Aviat Aircraft Inc.

SUBJECT: Stabilizer Support Tube Inspection and Repair

REVISION: A

HUSKY MODELS: A-1, A-1A, S/N 1468 & BELOW

1. Husky Repair Kit #SB-28 includes:

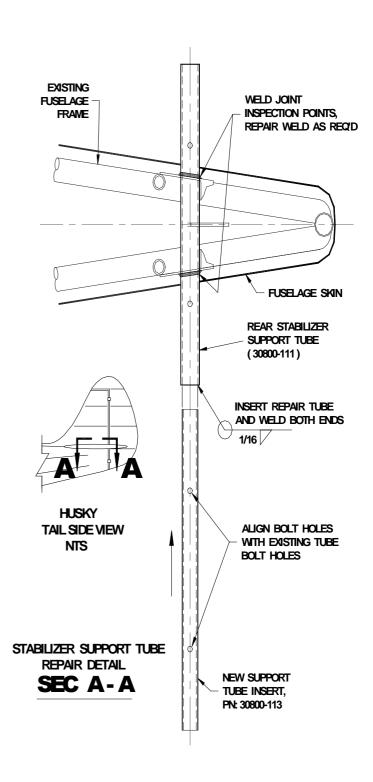
(4 ea) Stabilizer mounting bolts, and self-locking nuts

(1 ea) Stabilizer Tube, Rear

- e. Insert repair tube inside existing stabilizer support tube, align bolt holes, and weld both ends using AWS ER70S-2 welding rod in accordance with AC 43.13-1B, Chapter 5.
